ADDENDUM NO. 05

Replace 13 Elevators and 6 Escalators
Truman State Office Building
Jefferson City, MO
Project No: O2354-01

Replace 13 Elevators and 6
Escalators

MD-100

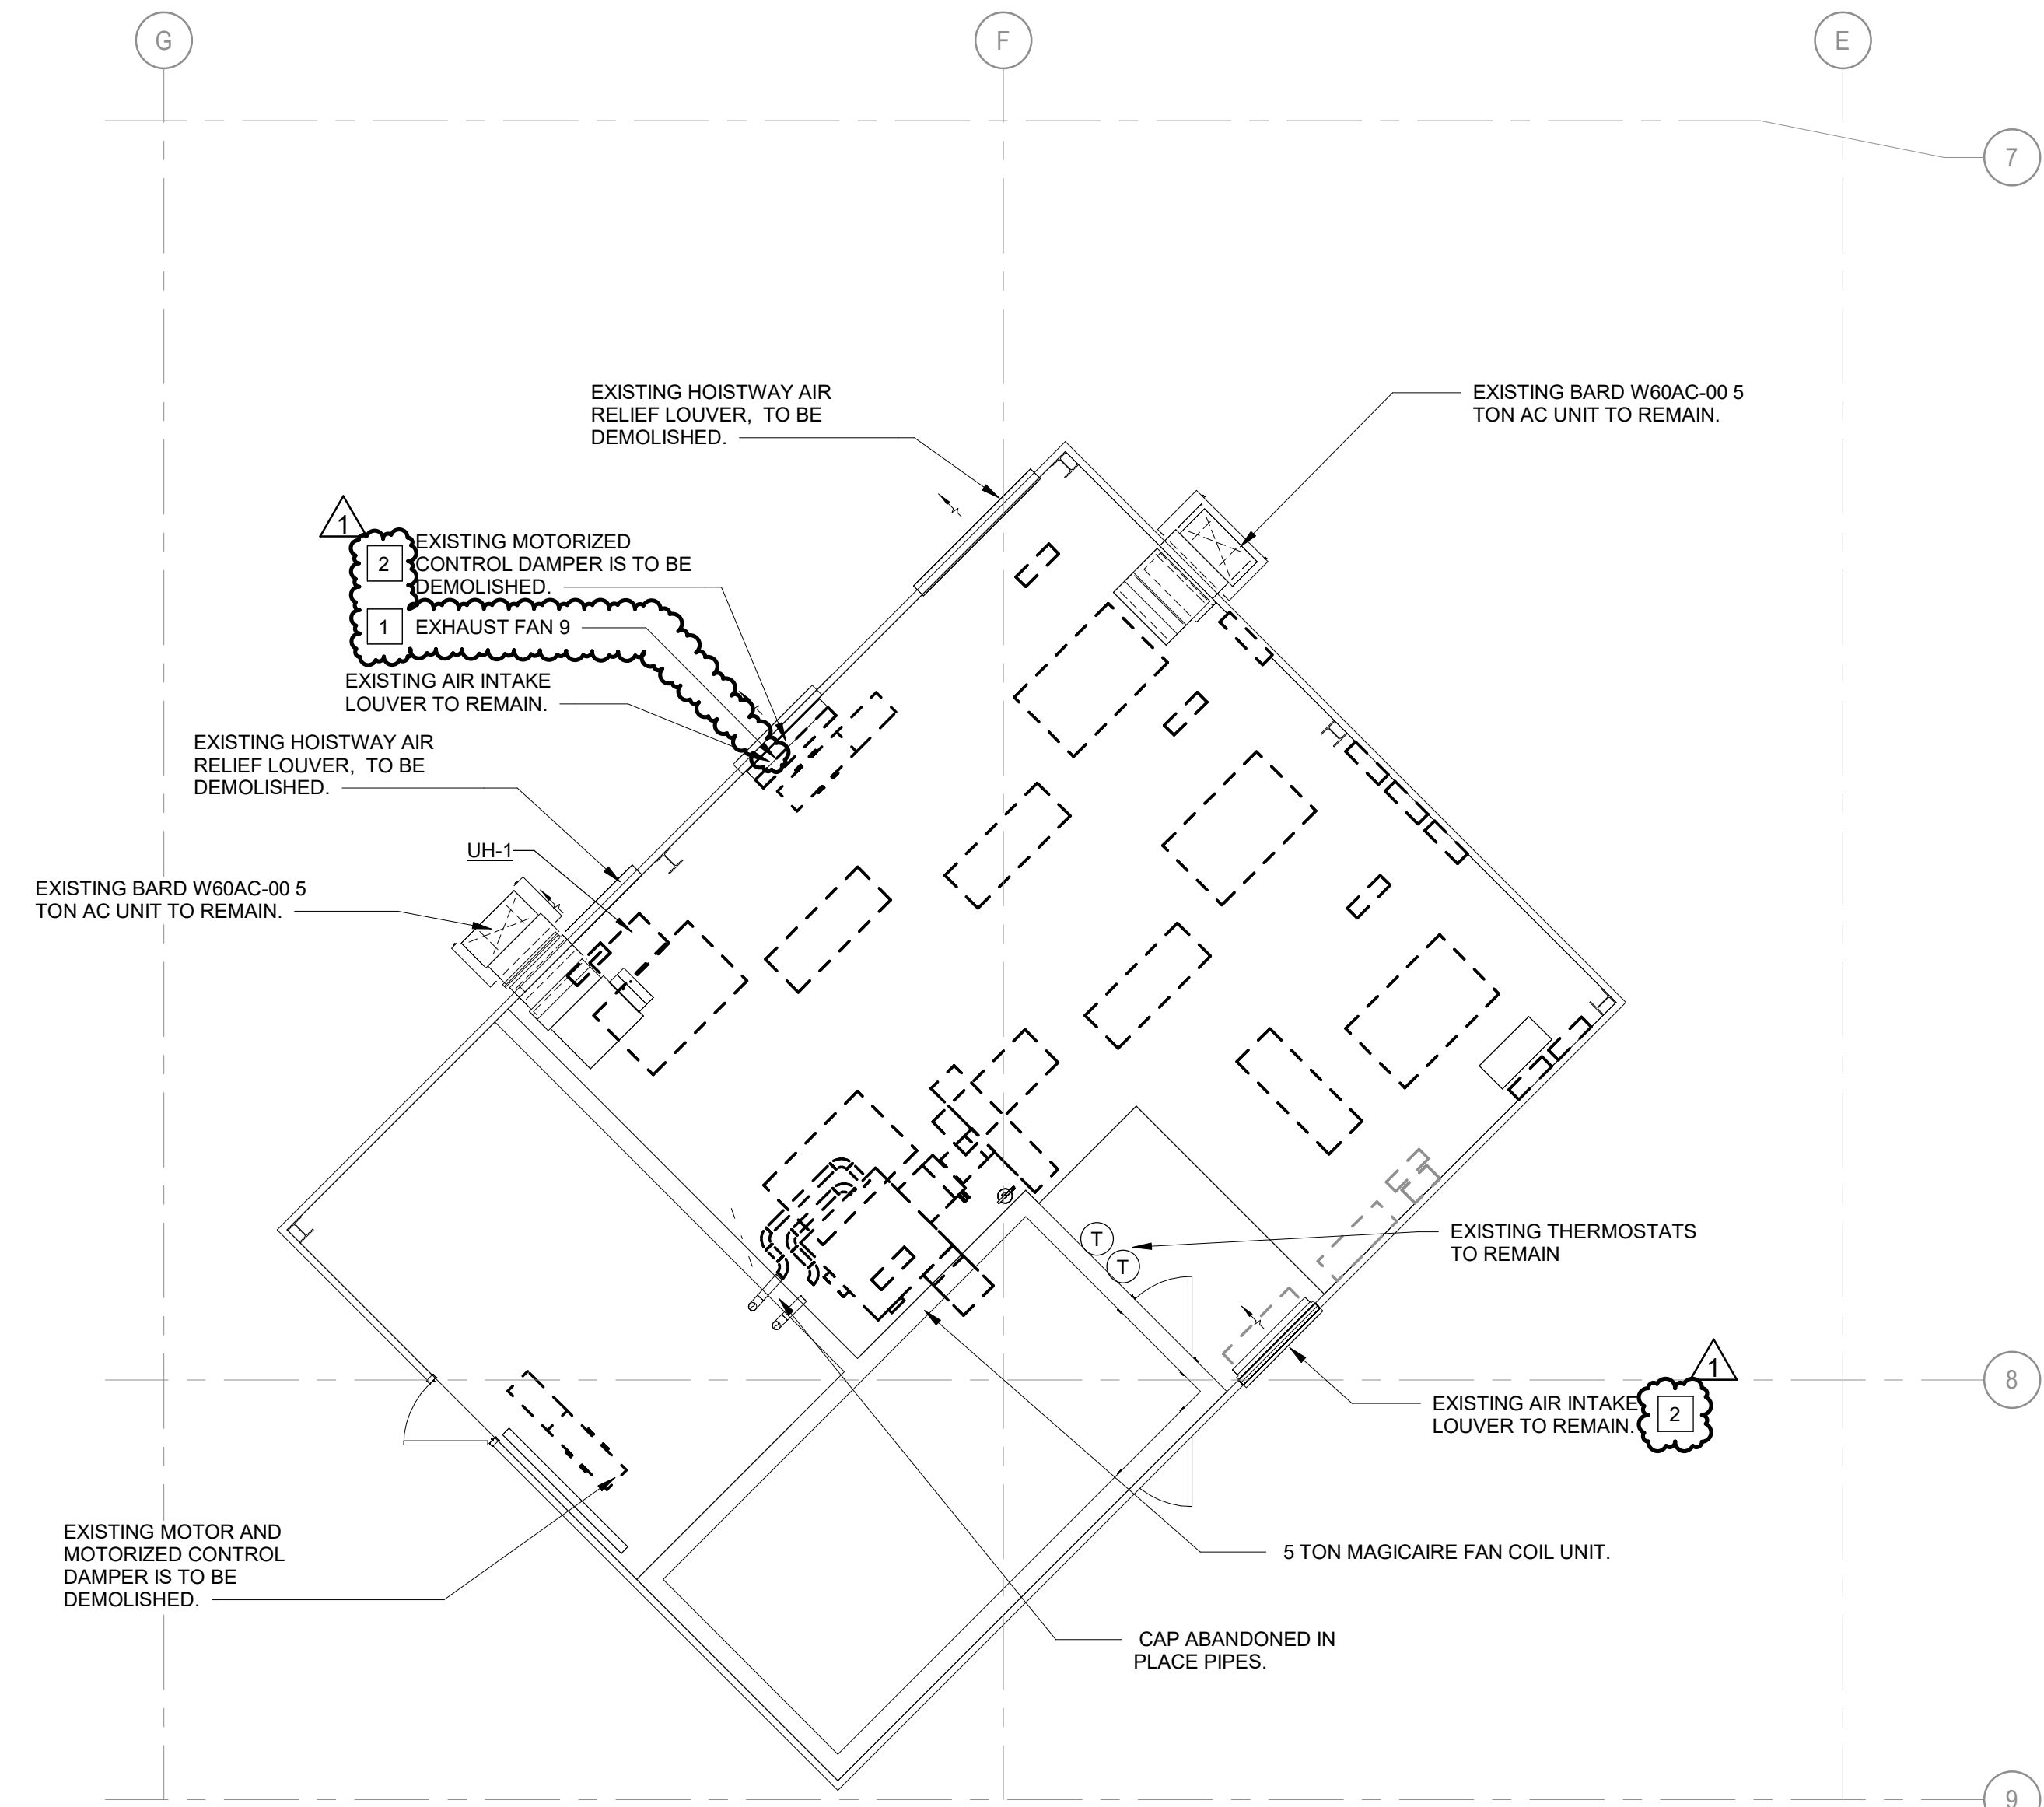
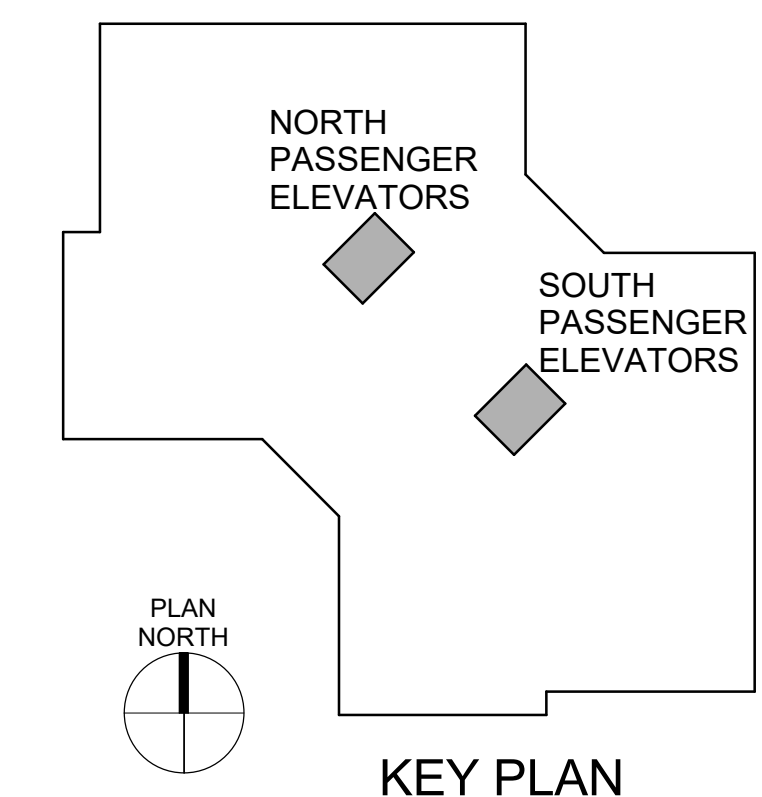
1. REPLACE Sheet MD-100 – See attached revised sheet M-100
2. REPLACE Sheet M-101 – See Attached revised sheet M-101
3. REPLACE Sheet M-108 – See Attached revised sheet M-108
 - a. Revisions Made:
 - i. Removed exhaust fans 8 & 9 from mechanical schedule.
 - ii. Exhaust Fan Controls removed.

#	SHEET KEYNOTES
1.	REMOVE EXHAUST FAN.
2.	BLANK OFF LOUVER WITH 1 INCH DOUBLE WALL PANEL.

M-101

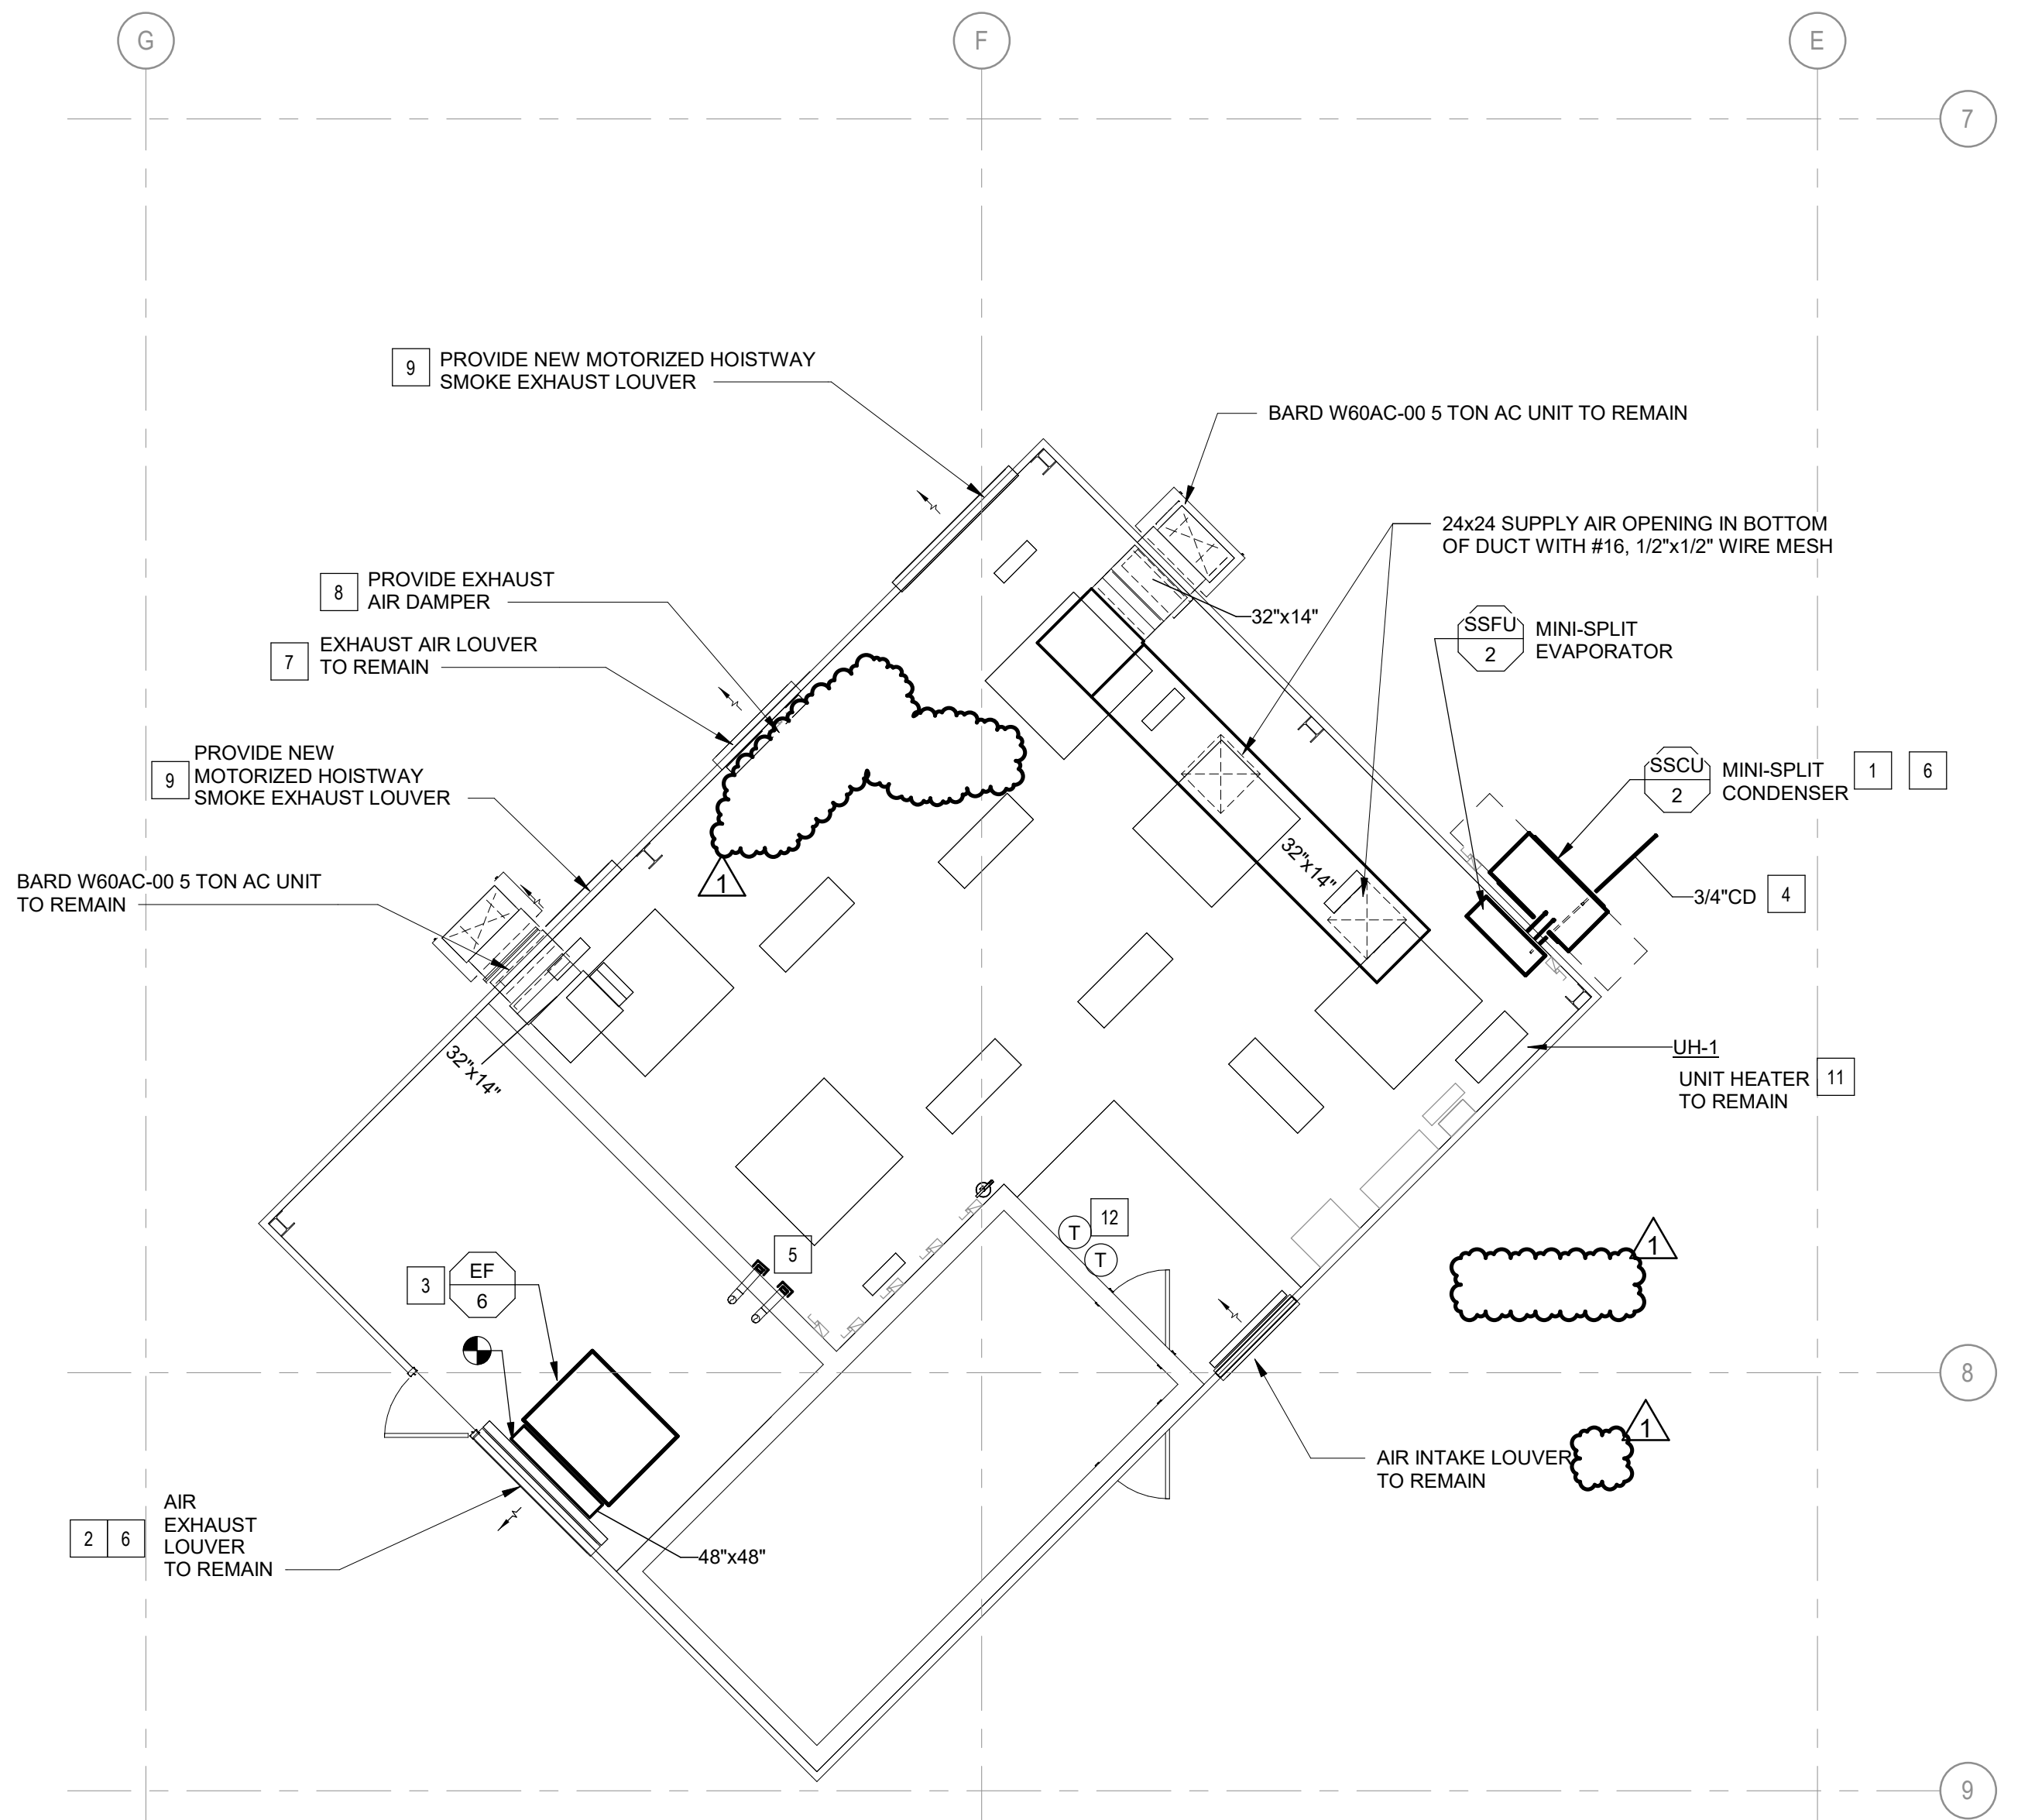
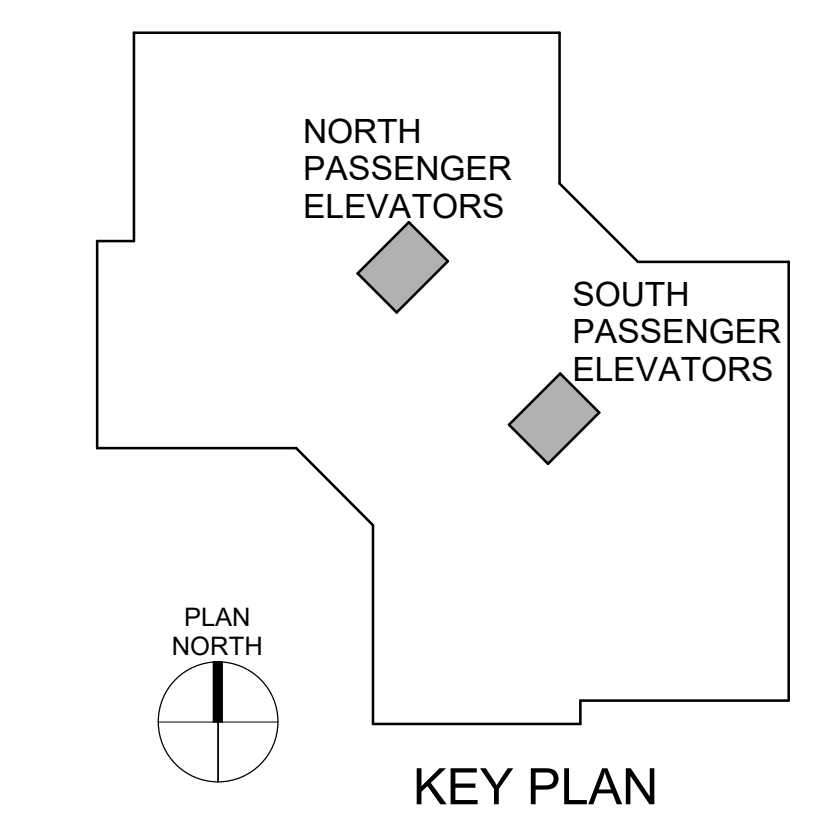
- b. The elevator penthouse will have three wall pack units. Will these wall pack units operate as stand alone?
 - i. The split DX systems will operate stand alone.

- c. The current chilled water unit in the elevator penthouse is controlled through the HVAC building automation system and is scheduled to be removed. Can the thermostat stay, and alarm the building automation system if the room temperature reaches a high and or low temperature limit?
 - i. The thermostats will be reused to monitor the space temperature of the penthouse and will alarm if out of range.
- d. The current outside air damper and exhaust fan are scheduled to be replaced. Is outdoor air required? In order to control the humidity better and help keep the room cleaner, would it be better to make sure none of the wall pack units pull in any outdoor air and eliminate the outdoor air dampers and exhaust fan?
 - i. The exhaust fans will be removed and the opening blanked off. The intake louver will be blanked off. The blank off will be a double wall insulated panel.
